CHILDREN'S HOSPITAL  
OF ORANGE COUNTY

TOWER II

LEVEL 1 ENLARGED PLAN  
AREA - A

A3.1A

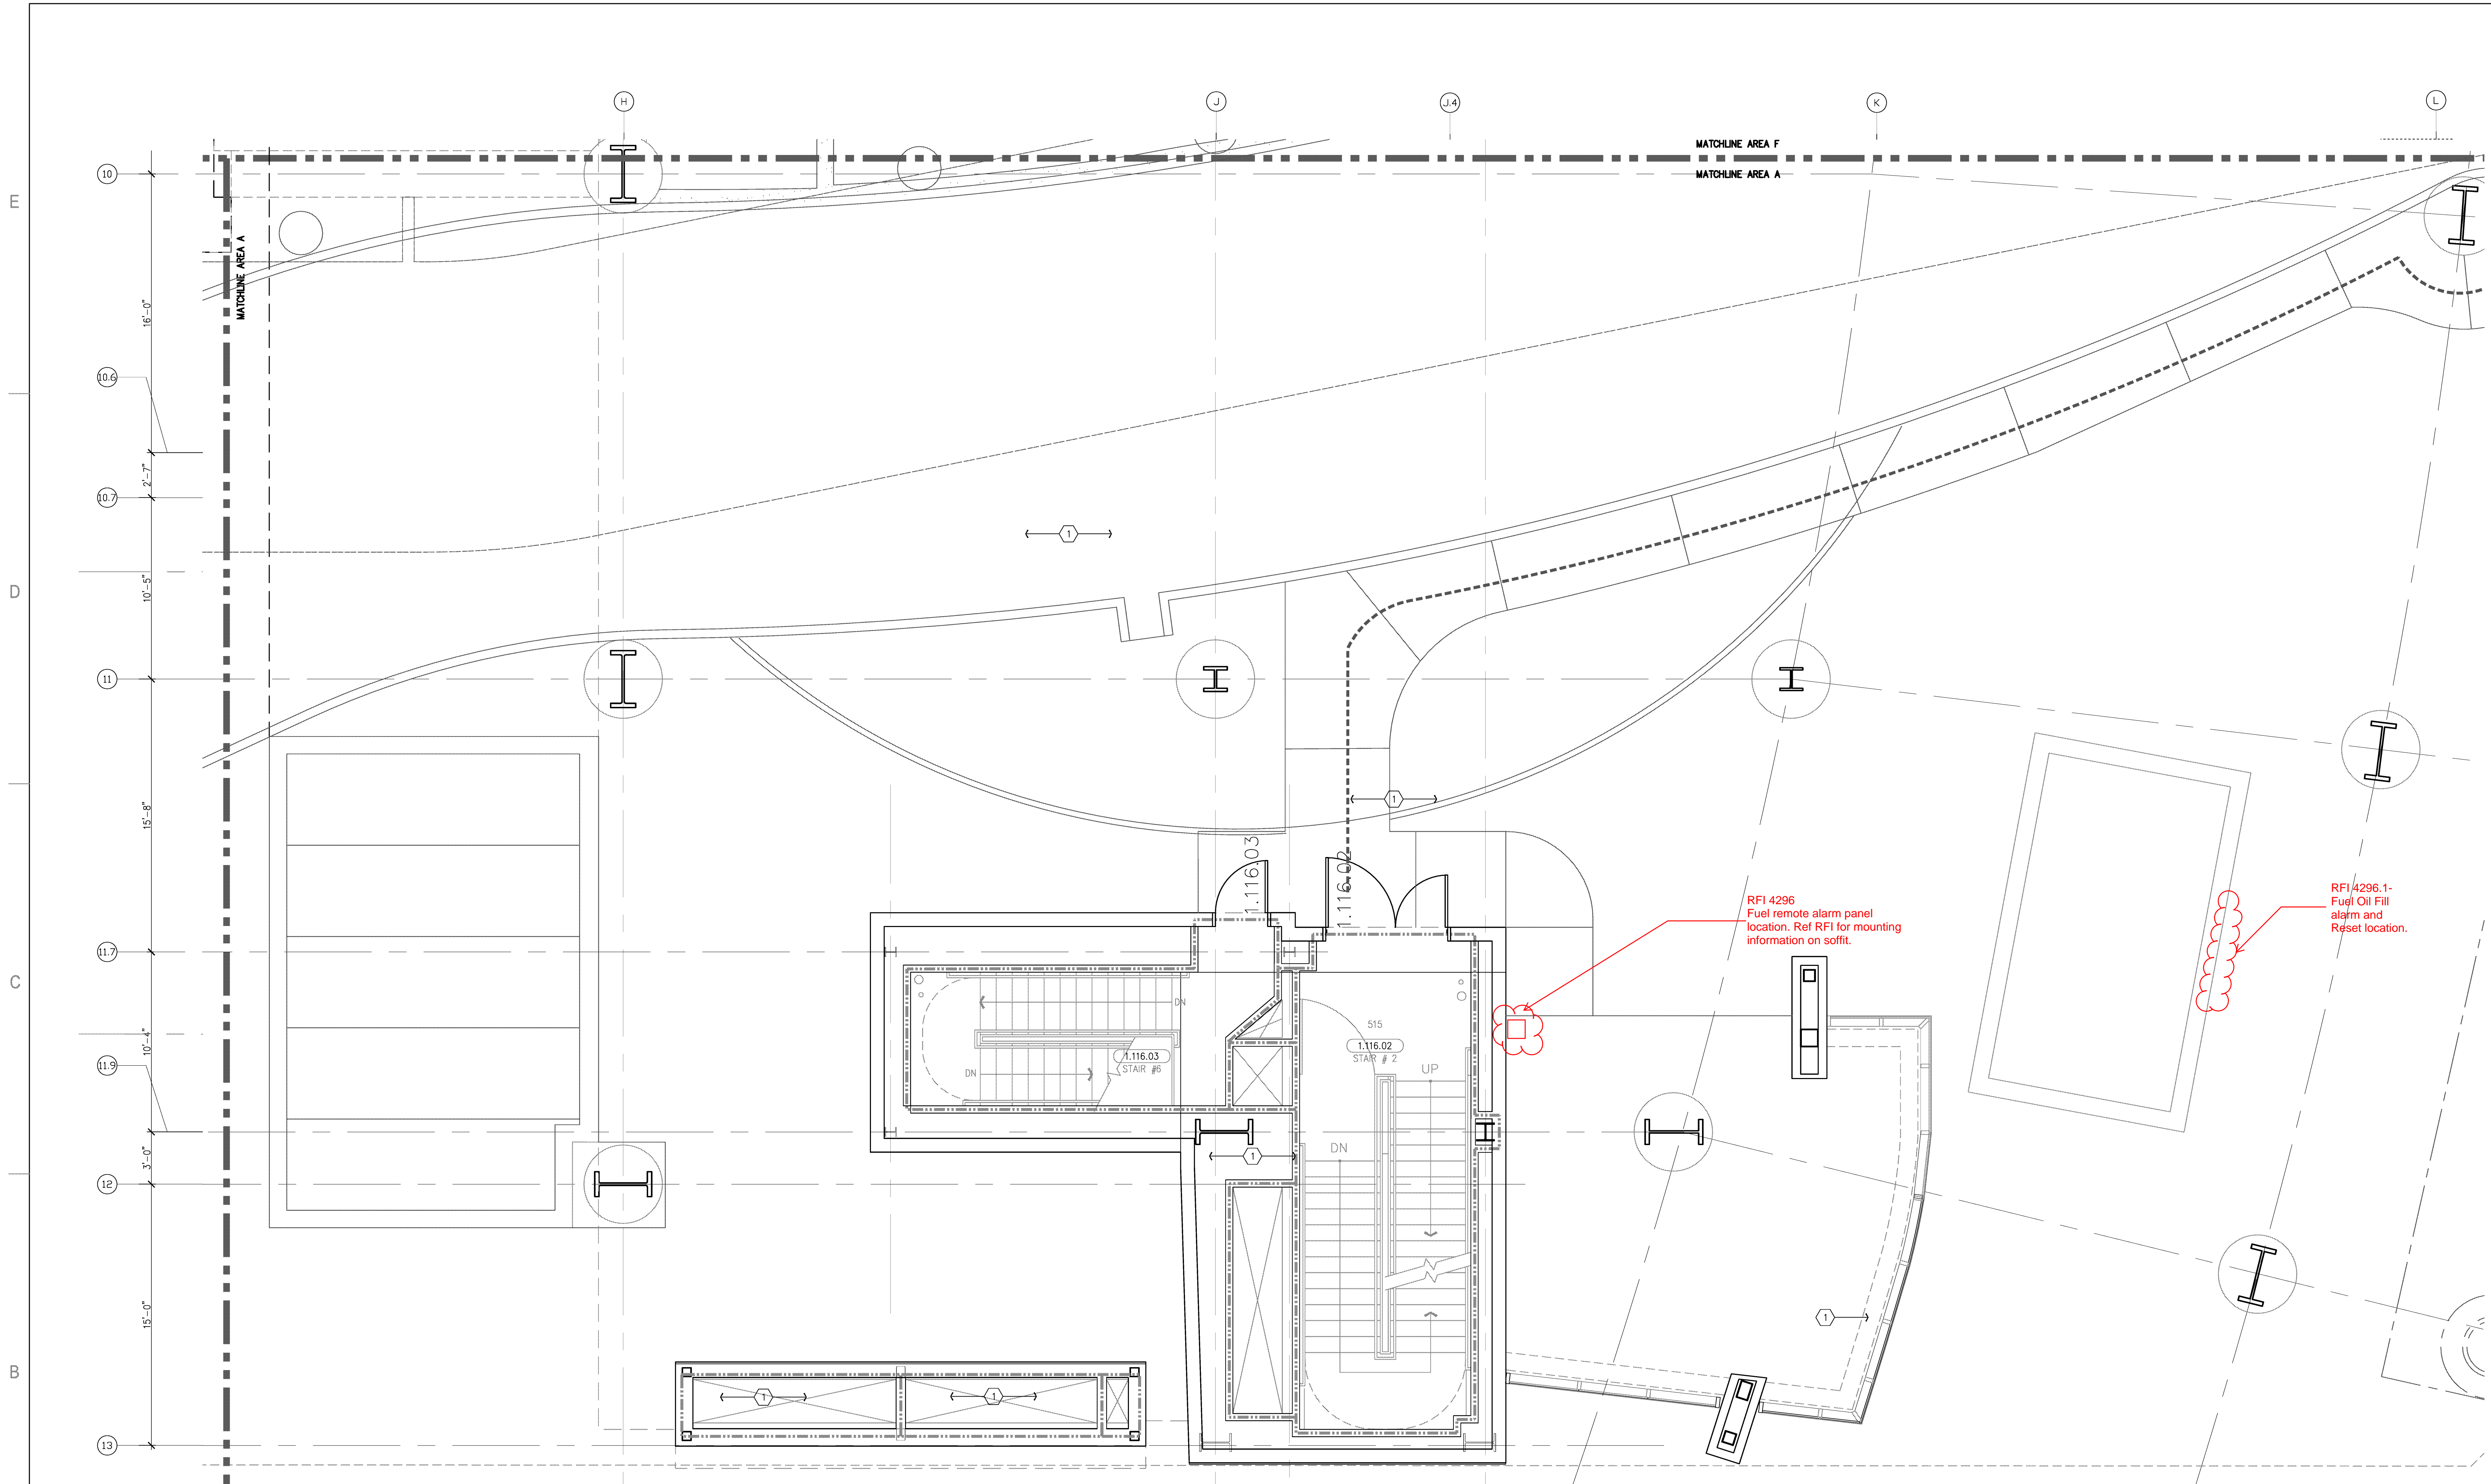
RFI 5099-0 for Grout Locations:  
Typ. all levels & areas
